**BEFORE THE PUBLIC UTILITIES COMMISSION  
OF THE STATE OF SOUTH DAKOTA**

IN THE MATTER OF THE APPLICATION )  
BY CROWNED RIDGE WIND II, LLC FOR )  
A PERMIT OF A WIND ENERGY )  
FACILITY IN DEUEL, GRANT )  
AND CODINGTON COUNTIES )

EL19-027

) **APPLICANT'S RESPONSES TO**  
) **STAFF'S FIRST SET OF DATA**  
) **REQUESTS TO APPLICANT**

Figure 1 Noise levels as a function of distance from the source wind turbine

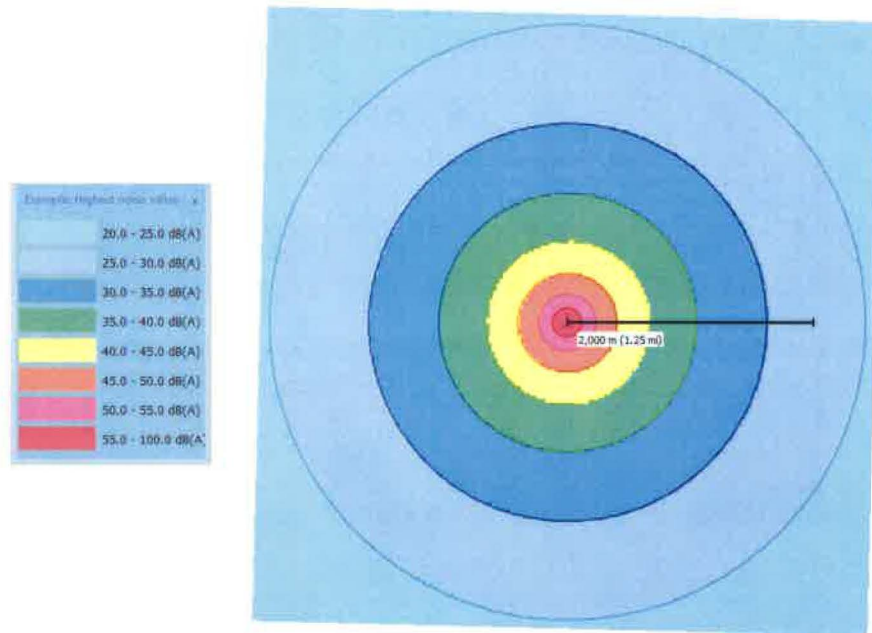
- 1-25) Refer to page 29 of the application. The only project identified by the applicant was Dakota Range I. Are Crowned Ridge I and Deuel Harvest included in all models and analysis in this docket as well? If so, explain why only Dakota Range I is identified on page 29.

**Response:** The introductory language on page 29 of the application provided an overview of the project area, and mentioned Dakota Range I as an example. More specifically, the Sound Report, Appendix I at pages 1, 8-9 identified that the Crowned Ridge Wind I and Deuel Harvest turbines were included in the cumulative sound impact analysis, while Dakota Range turbines were not included because they are too far away to have any significant cumulative impacts on the Crowned Ridge II wind farm. Also, Shadow Flicker Report, Appendix J, at pages 1 and 8 explains that only Crowned Ridge Wind I was included in the cumulative impact analysis, because the Deuel Harvest and Dakota Range turbines are too far away to have any significant cumulative shadow flicker impacts on the Crowned Ridge Wind II project. Turbines that are more than 2 km (1.25 mi.) away from a receptor will have minimal (less than 30 dBA) noise impacts and no shadow flicker impacts.

The two figures below demonstrate the noise and shadow flicker levels as a function of distance from the wind turbine.
